# SERVICE BULLETIN

No. 604A

Piper Aircraft Corporation

PART I: Forward Baggage Door Locking System Modification

FIGURE 1

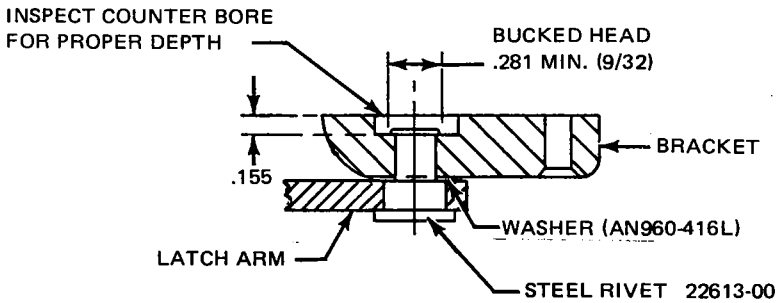
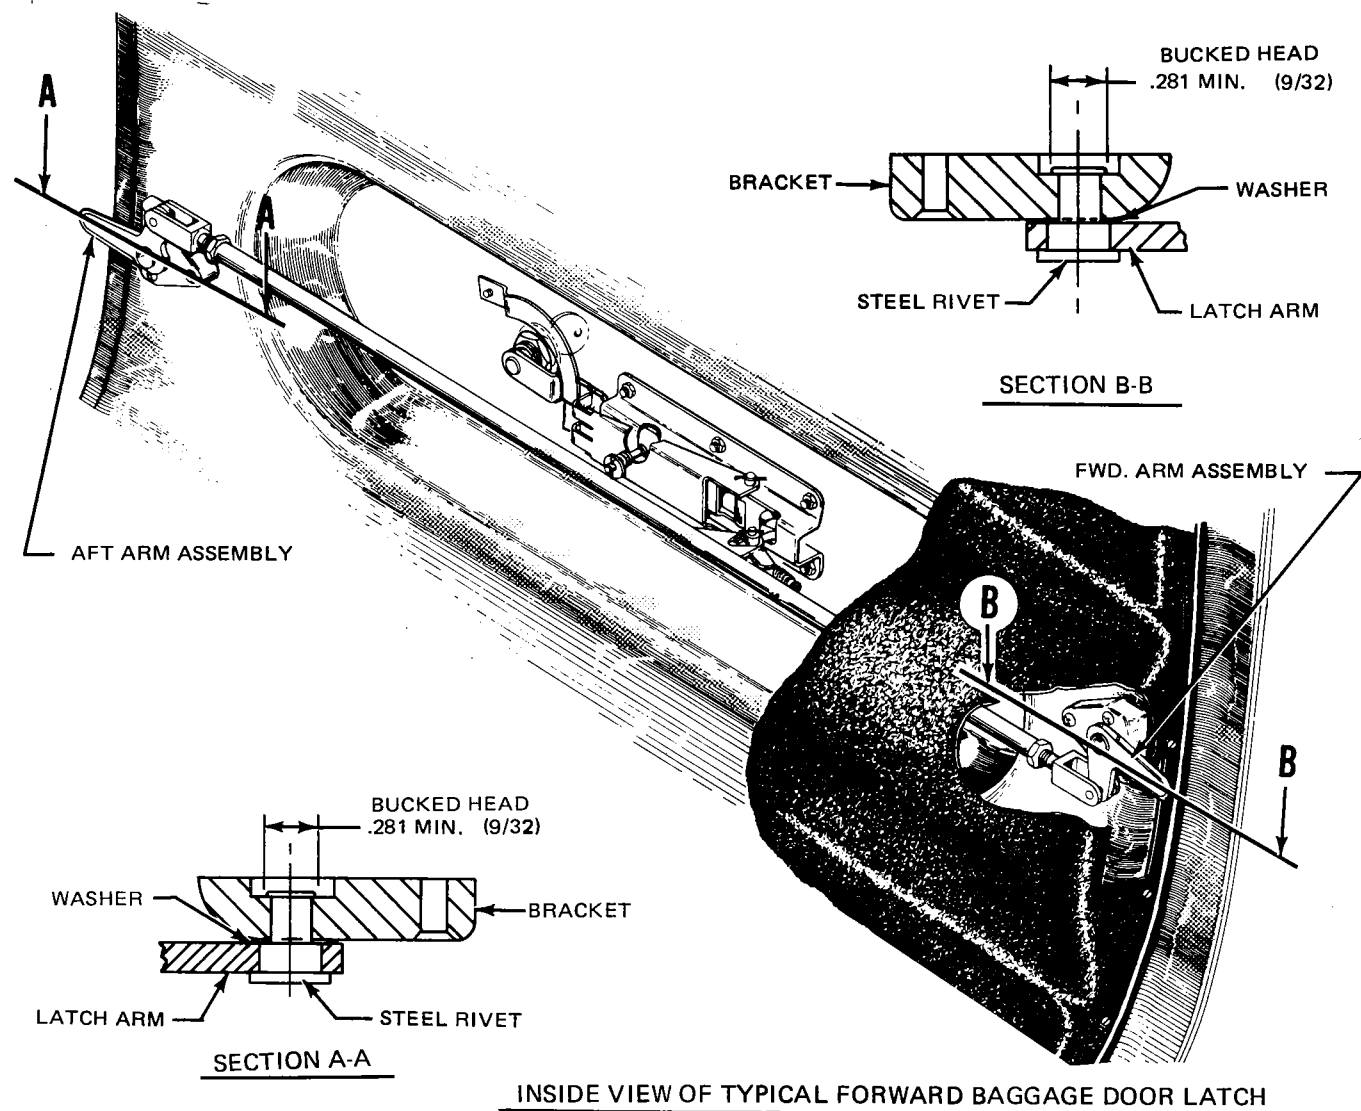
The door lock arm assemblies on the forward or nose, baggage door on the above referenced models are secured to brackets by steel rivets. It has been determined that for optimum arm assembly-to-bracket security, the bucked (peened) head of the rivet should have a diameter of .281 inch or greater.

1. Refer to Section IV in the appropriate Service Manual and remove the door latch arm assemblies from the forward baggage door.
2. With the latch arm assemblies removed from the door, inspect as follows.
  - a. Measure the diameter of the bucked head of the steel rivet that secures the latch arm to the bracket (Refer to Section A-A and B-B on Sketch A). This diameter must be .281 (9/32) or greater.
3. Latch arm assemblies with a bucked head diameter of .281 (9/32) or greater may be considered acceptable.
4. Latch arm assemblies with a bucked head diameter of less than .281 (9/32), must either be replaced with a new part as listed in the table below or may be reworked as follows.
  - a. Peen rivet head, in an acceptable manner, to achieve a bucked head diameter of .281 (9/32) or greater, as shown.

NOTE: Latch arm assemblies not retaining freedom of rotational movement, after head of rivet is peened, must be replaced with a new part as listed in Table below or steel rivet may be replaced as follows. (Refer to Sketch "A", Figure 1. )

- (1) Carefully drill out steel rivet. Maximum allowable hole size after drilling is .267.
  - (2) Inspect the .50 diameter counter bore in bracket to determine if counter bore is the proper depth as shown. Counter bore the hole to .155 if it is not the proper depth.
  - (3) Install new rivet Part No. 22613-00 and peen in an acceptable manner to achieve a bucked head diameter of .281 (9/32) or larger.

NOTE: Latch arm assemblies not retaining freedom of rotational movement after rework, must be replaced with a new part as listed in Table below.
5. Install new or reworked latch arm assemblies to forward baggage door. Refer to Section IV in the appropriate Service Manual.
6. Make proper Logbook entry of Service Bulletin 604A "Part II" compliance.
